Appl. No. 10/709,682
Amdt. dated May 25, 2006
Reply to Office action of Feb. 28, 2006

Amendments to the Drawings:

ARH SUPPORT WITH HOUSE PAD
ANDREA BOMBELLI

Fig. 2

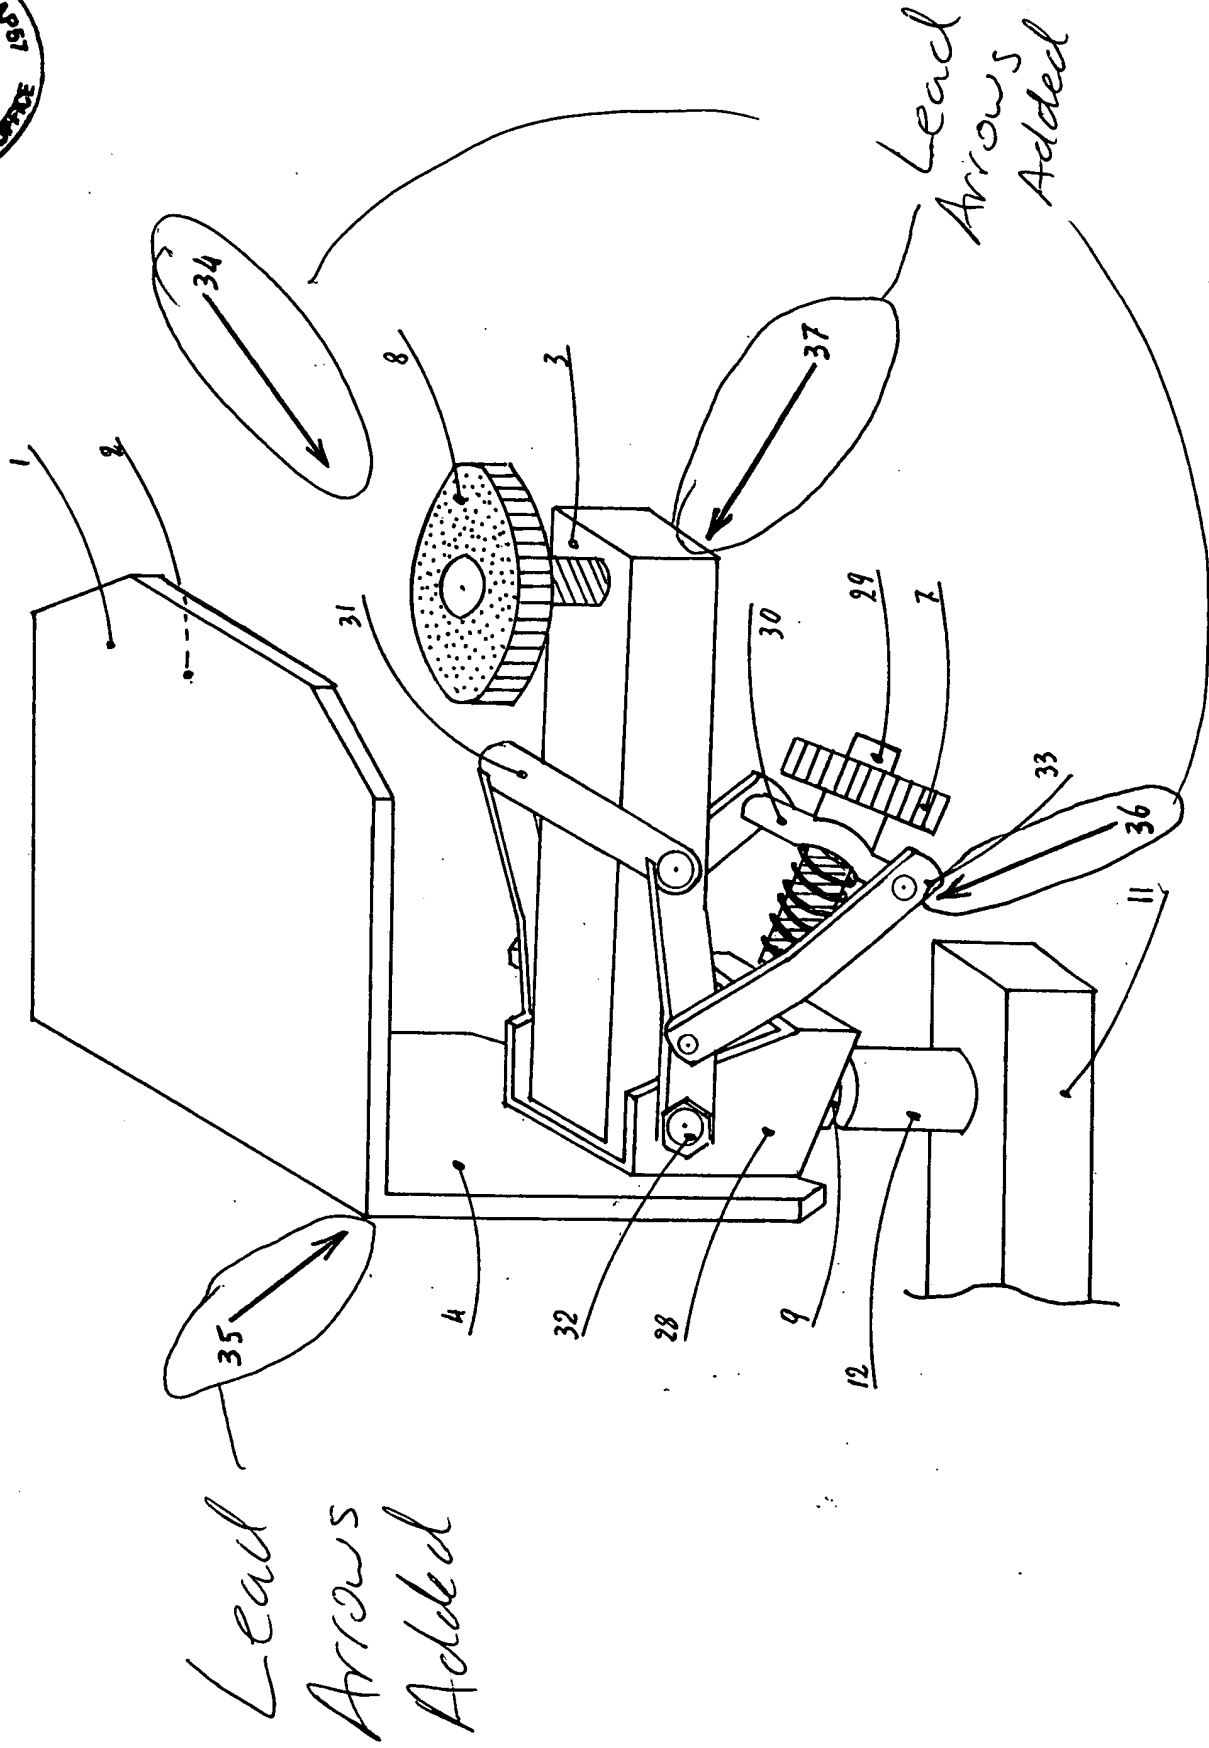
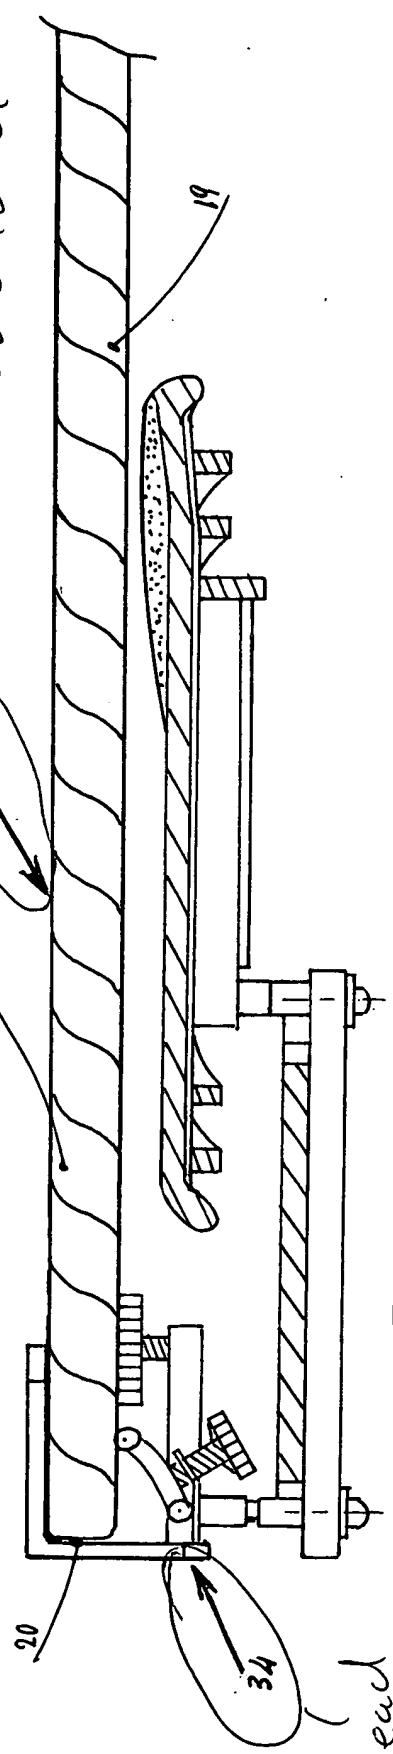
ARM SUPPORT WITH MOUSE PAD
 ANDREA BOMBELLI
 Lead Arrow added

Fig. 3 (a)

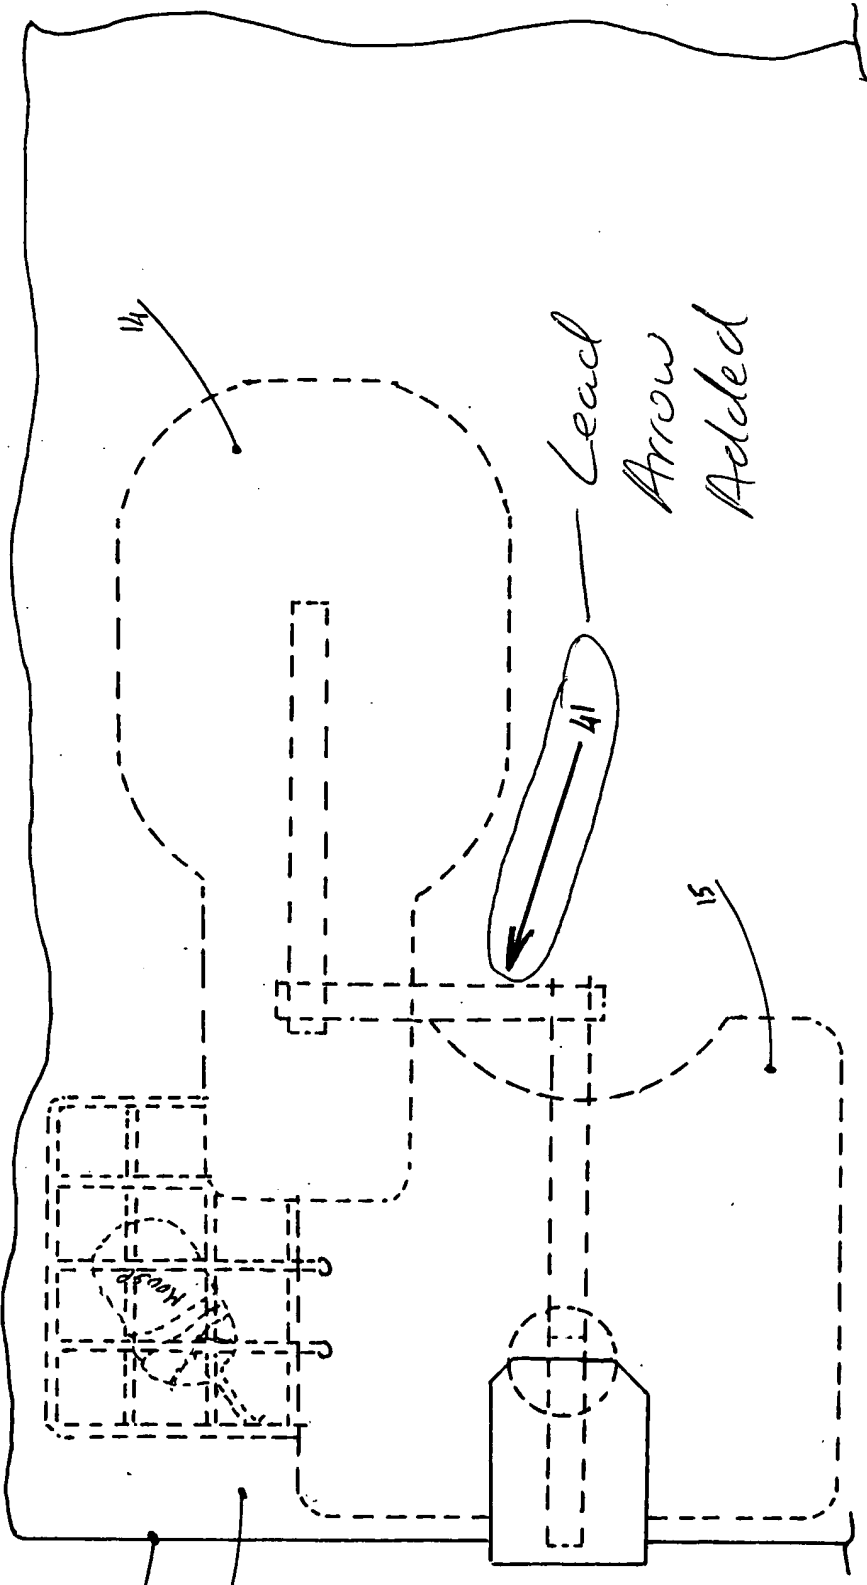
Lead Arrow Added 20

Lead Arrow Added

Fig. 4(a)

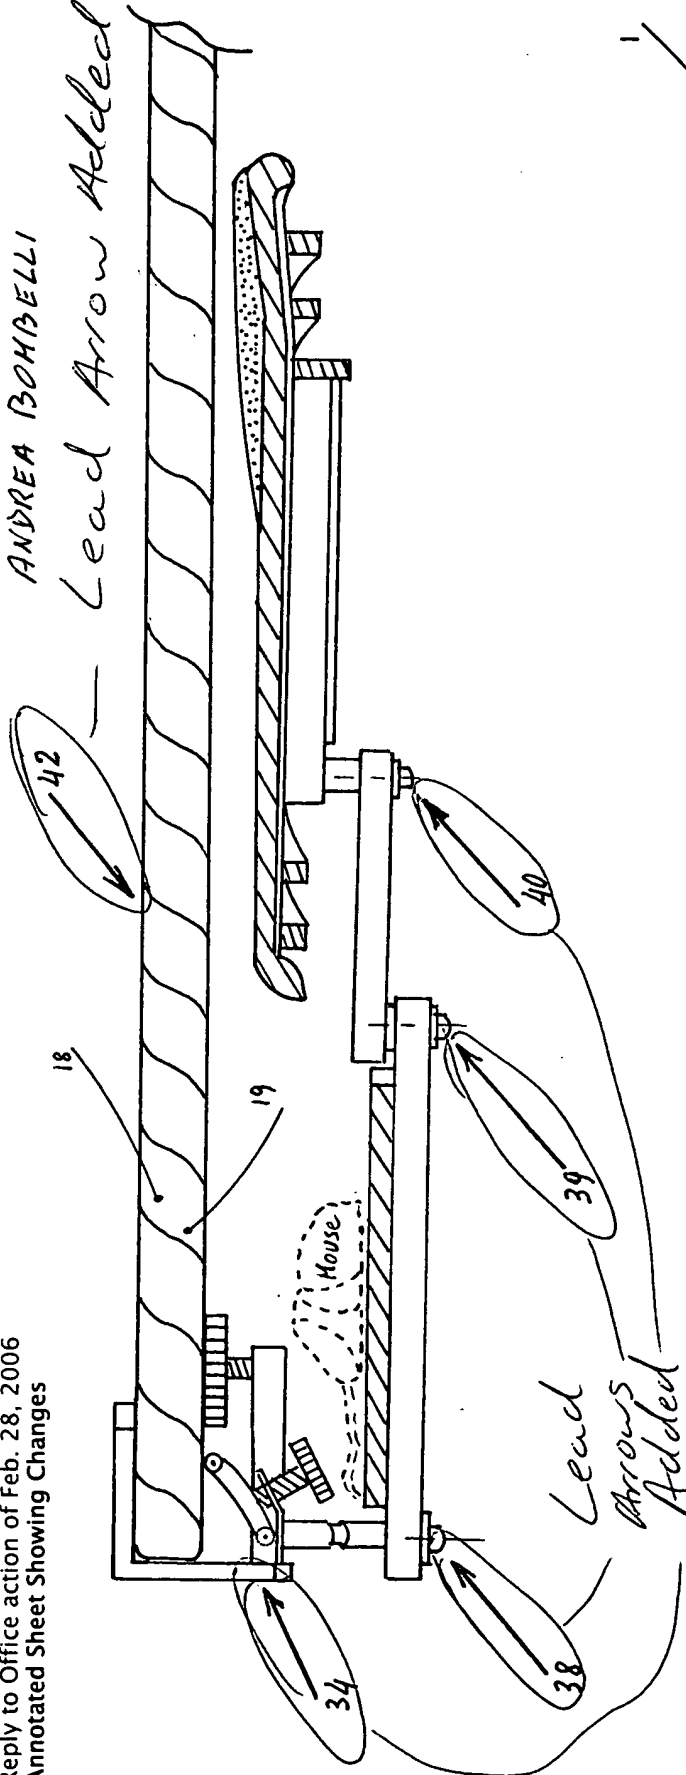
Lead Arrow Added

Fig. 5 (b)

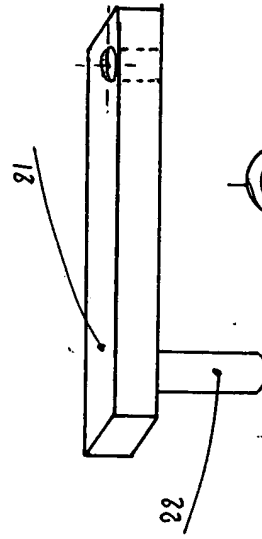
In Figure 5(b), a bracket has been added as requested by Examiner to comply with rule 184(h)(1).

Bracket
Added
